**LAND ADJ 4 SHELDONS COTTAGES  
TWO BEDROOM, TWO STOREY, DWELLING  
CONSENT 19/02553/FUL**

This document and the site plan REV/21/02/A provide details regarding the application for a non-material amendment to the approved parking.

*Excerpt A from SC/19/01/B*

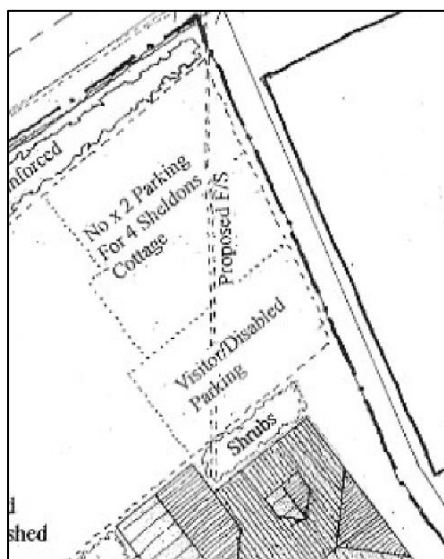
As detailed in SC/19/01/B and shown in excerpts below, the approved parking consists of five parking spaces: Two tandem spaces for the new property next to the boundary (Excerpt A) and three spaces to the front of the property (Excerpt B). The latter being two for the existing property (4 Sheldons Cottages) and a shared visitor space.

The boundary between the new property and Thatched Cottage is primarily hedgerow and excerpt A above shows the existing hedging and the new hedging to be planted where the small garage<sup>1</sup> shown in dotted lines was situated.
